Discussion of magnetic sensor upgrade plan for NSTX-U

NSTX-U 5 Year Plan Meeting

January 11th, 2013

Upgraded magnetic sensor plan status discussed at recent meeting

SPG Idea #1: Mount them under Secondary Passive Plate Lip

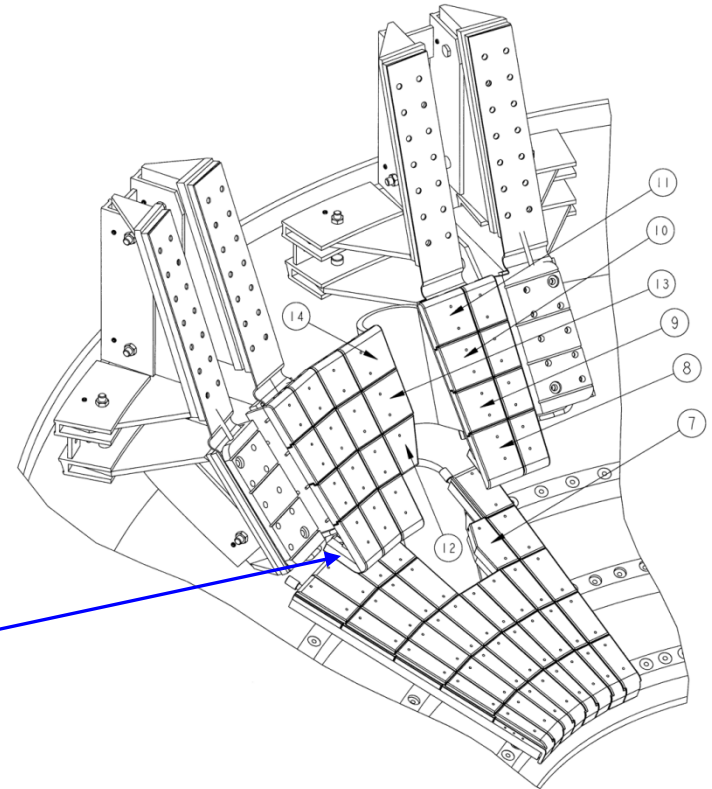
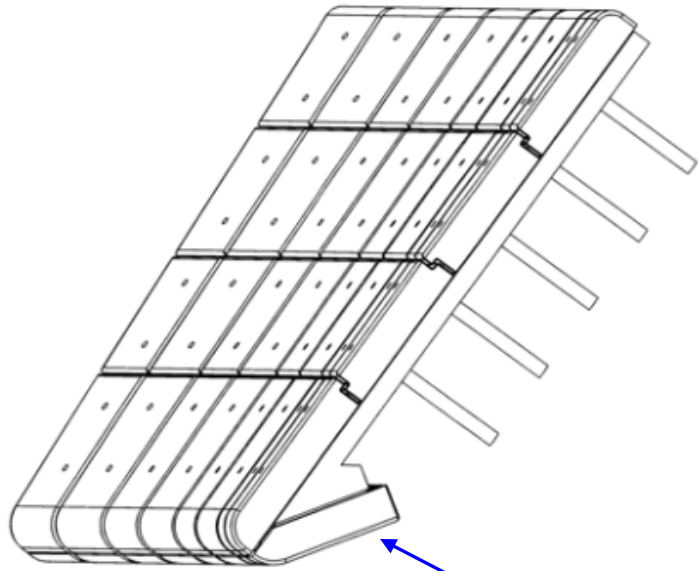
- Replace this tile with sensor box.
- Would be partially shielded by SPP
- Might need to retain part of the front of the tile, but much could likely be eliminated.
- Wire extraction fairly simple.
- Boxes may need to be curved to follow outline of plate.

SPG Idea #2: Mount them under outer divertor bull nose tiles

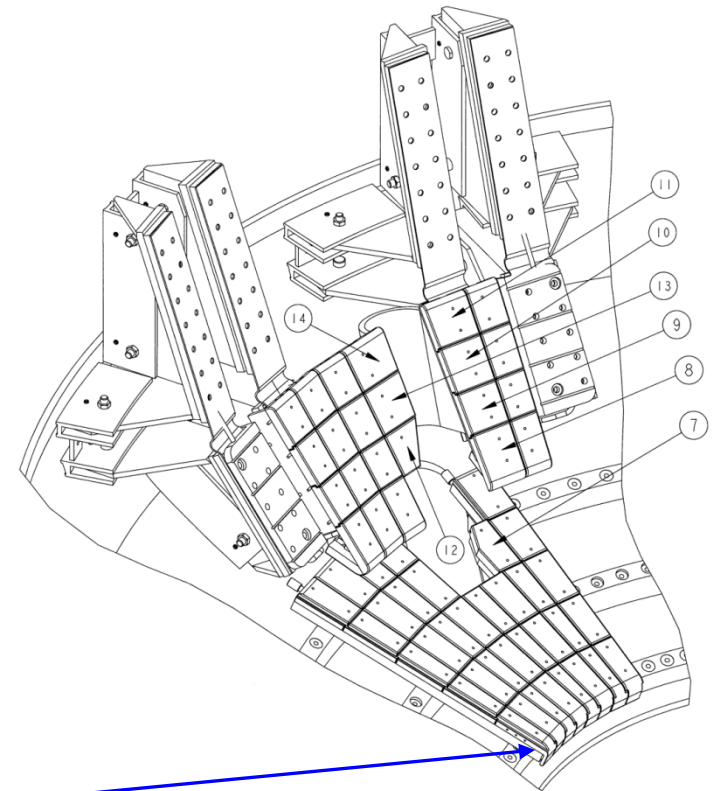
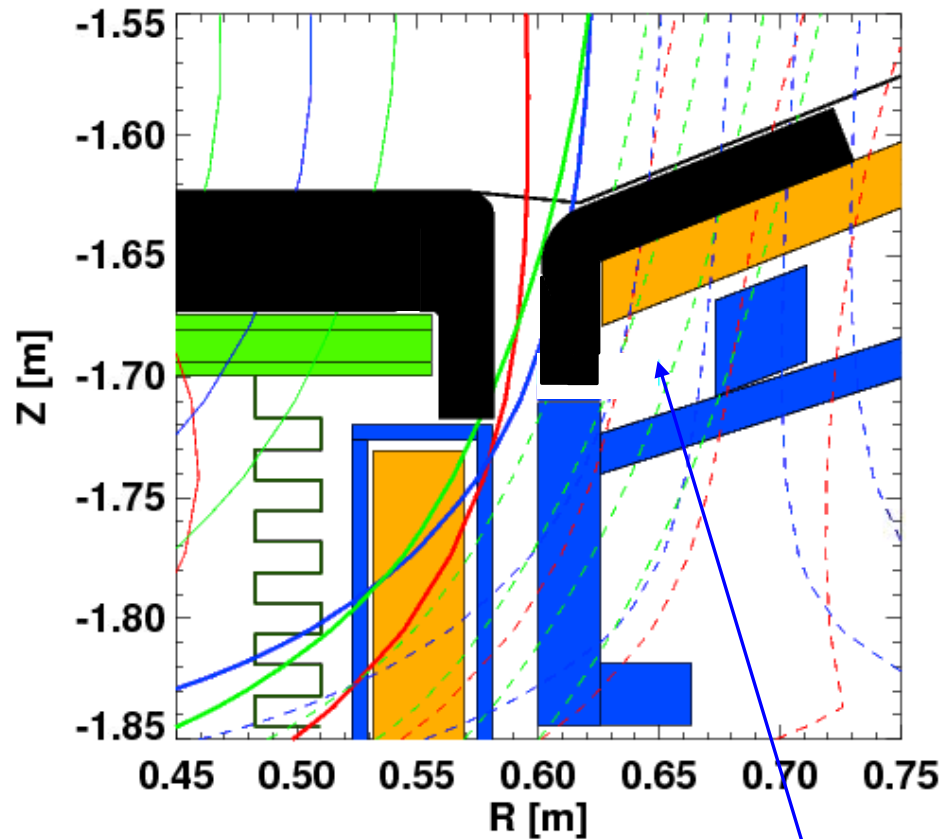
- Place curved sensor box in this volume.
- Is reasonably well shielded from plasma by improved bull-nose tiles.
- Wire extraction likely to be difficult.
- Would be partially electromagnetically shielded by divertor.

SPG Idea #3: Sensors in Tiles

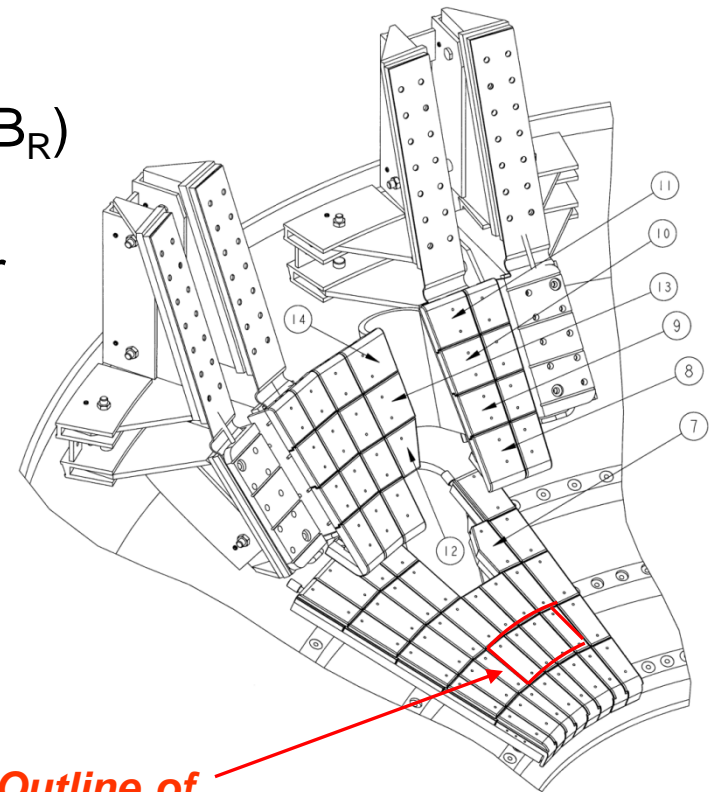
- ❑ Tiles are only about 0.9" thick, and have a T-bar right down the center.
 - ❑ Makes installation of a traditional B_P ($\sim B_R$) sensor difficult.
 - ❑ Could imagine a very thin "Hiro" sensor mounted above the T-bar.
- ❑ Could fabricate a single larger tile, taking the area of 2-4 existing tiles.
 - ❑ Wrap a B_N ($\sim B_Z$) sensor around the tile edges.
 - Sort of like how the B_R sensors are mounted to the PPPs
 - ❑ Would likely trap the t-bars
 - ❑ Are there thermal issues with larger tiles?
 - ❑ Need to check the effective area.
